WEST HELENA AR

APRIL 2018

Recommendations for Sunken Pool

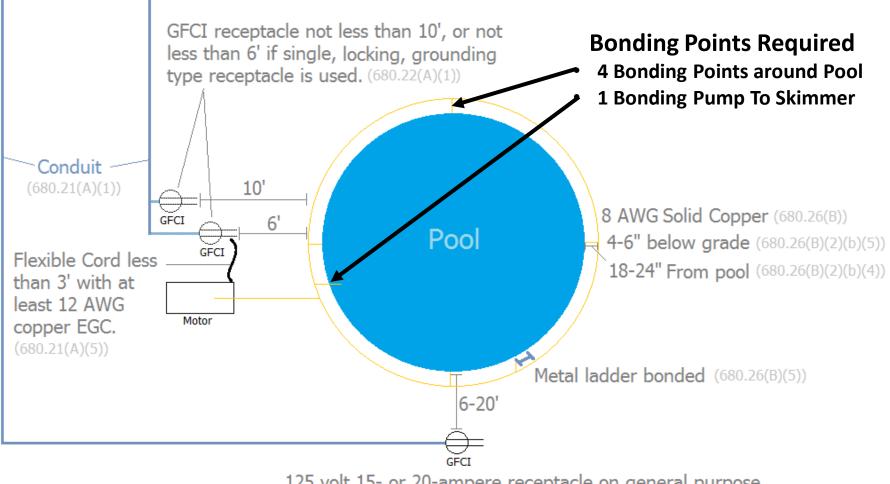
125 volt 15- or 20-ampere receptacle on general purpose branch circuit. more than 6', and less than 20' from inside wall of pool. Must be GFCI protected. (680.22(A)(3))

Recommended area for bonding ground. This will bond pool and retain manufacturers warranty.

In order to Ground: 1) The housing needs to be pulled. 2) The wire can be inserted through the vent to attach to the lug. 3) Reassemble the motor housing.

Option: Ask local code if using the 25' cord with GFCI plug would be to code? p/n 1-2364-570 p/n 1-2365-570 p/n 1-2366-570

Recommended areas for bonding ground. Any of the 3 will bond pool and retain manufacturers warranty.
